**Staff Report**  
**City of Richmond, Virginia**

**Commission of Architectural Review**

2. COA-173644-2025	Final Review	Meeting Date: 10/28/2025
Applicant/Petitioner	Dianna Jennings Macon	
Project Description	Replace porch decking, posts, railings, and structural elements, and install new screen and three storm doors.	
Project Location		
Address: 2917 East Broad Street		
Historic District: St. John's Church		
<p>High-Level Details:</p> <p>The applicant proposes to the following work to the rear/side porch of a brick, Italianate Row House circa 1888:</p> <ul style="list-style-type: none"> <li>• Replace existing floor joists with pressure treated wood.</li> <li>• Replace existing porch decking with Azek Timber Tech-Rustic Elm synthetic boards.</li> <li>• Replace porch posts with new 6x6 pressure treated posts.</li> <li>• Replace existing wood railing with new white vinyl railings and vinyl square pickets.</li> <li>• Install screen in both levels of the porch and install three screen doors.</li> </ul>

Figure 8. 1905 Sanborn Map. Porch in its original configuration without the new landing and stair extension off the rear.

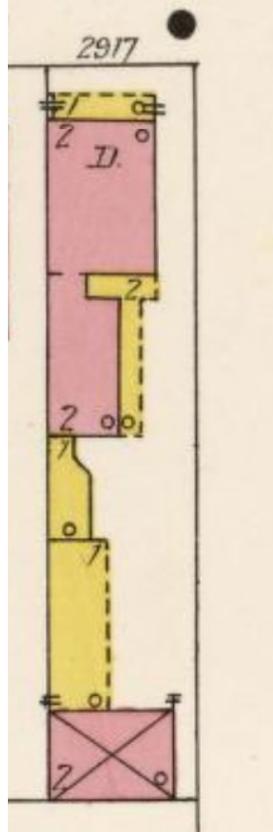
Guideline Reference	Reference Text	Analysis
<b>Building Elements, Porch and Entrance Repair, pg. 71</b>	<i>1. Elements that are damaged or loose should be repaired to match the detail of the existing original fabric.</i>	The applicant is proposing to replace various components of the building's rear/side porch.
<b>Building Elements, Entrance and Porch Removal, Replacement and Reconstruction, pg. 71</b>	<p><i>4. Do not remove or radically change entrances and porches important in defining the building's overall historic character. Front and side porches are architecturally more ornate than utilitarian back porches.</i></p> <p><i>7. When replacing a railing on a historic building which has lost its railing, the first step is to look for documentary evidence which records the appearance of that railing. If no documentary evidence survives, look for physical evidence (this may benefit from the help of a design professional).</i></p> <p><i>8. Do not strip entrances and porches of historic material and details that should be retained in any repair or partial replacement.</i></p>	<p>The existing porch is comprised of an original 42' section, and then a newer, 6' extension off the rear that consists of a landing and stairs for access to the second story porch. Overall, the porch is simple in design being two stories in height and featuring wooden Richmond Rail and square posts with simple molding around their bases, tops, and necks.</p> <p>The existing square posts will be replaced with new pressure treated 6x6 square wooden posts. The drawings submitted indicate that there will be some molding around the base and tops of the new square posts; however, the exact design is not clear. The dimension and detail of the new posts should match that of the extant posts (See figure #7). <u>Staff recommends that the applicant submit a detail drawing of one of the proposed posts to staff for review that demonstrates that the molding around the top, neck, and base of the posts will match that of the extant posts.</u></p> <p>The existing porch features wooden tongue and groove decking boards. The applicant proposes to replace the existing decking with Azek Timber Tech decking boards in the Rustic Elm Color. Based on the information submitted, the dimensions of the new boards are unclear. <u>Staff recommends approval of the synthetic decking boards with the following conditions: The width of the boards match the existing as closely as possible, the decking boards have a tongue and groove profile, the decking boards be installed perpendicular to the face of the building, and that final decking material specifications be submitted to staff for review and approval.</u></p>
